Access Compliance Report

Public Rights-of-Way

(Curb Ramps)

Intersection ID: 49932	Main Street: WOBURN_RD	Cross Street: PAXTON_RUN_RD	Location: SW
ADA ID: 7305D98A0B3A	Ramp Type: Perp	Initial Pass/Fail: Fail	Overall Compliance: No
Severity Score: 25			
Codes/Mitigation Info/Possible Solution		Field Measurements/Component Compliance

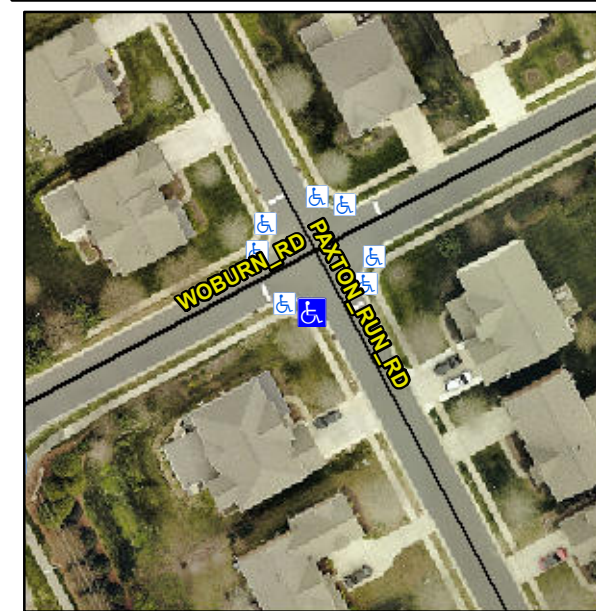
Not Found, R304.2.2, R304.5.3

Compliance	Description	Data	Compliance	Description	Data
N/A	Ramp Length (in)	47.0	No	Ramp Slope (%)	10.2
Yes	Ramp Width (in)	48.0	No	Ramp XSlope (%)	5.9
N/A	Flare Type LT	N/A	N/A	Flare Type RT	N/A
N/A	Flare Slope LT (%)	N/A	N/A	Flare Slope RT (%)	N/A
N/A	Flare Traversable LT?	N/A	N/A	Flare Traversable RT?	N/A
N/A	Landing Length (in)	N/A	N/A	DWS Provided?	N/A
N/A	Landing Width (in)	N/A	N/A	DWS Contrast?	N/A
N/A	Landing Slope (%)	N/A	N/A	DWS Length (in)	N/A
N/A	Landing X Slope (%)	N/A	N/A	DWS Full Width?	N/A
N/A	Landing Curb? (Y/N)	N/A	N/A	DWS Offset (in)	N/A
N/A	Shared Landing?	N/A			
N/A	Gutter Ponding?	N/A	N/A	Gutter Slope (%)	N/A
N/A	Gutter Lip Ht (in)	N/A	N/A	Gutter X Slope (%)	N/A
N/A	Painted X Walk1?	No	N/A	Painted X Walk2?	N/A
	X Walk 1 Direction	To NE		X Walk 2 Direction	N/A
N/A	X Walk 1 Width (in)	N/A	N/A	X Walk 2 Width (in)	N/A
	X Walk 1 Slope (%)	1.4		X Walk 2 Slope (%)	N/A
	X Walk 1 X Slope (%)	3.4		X Walk 2 X Slope (%)	N/A

Remove & Replace Entire Ramp.
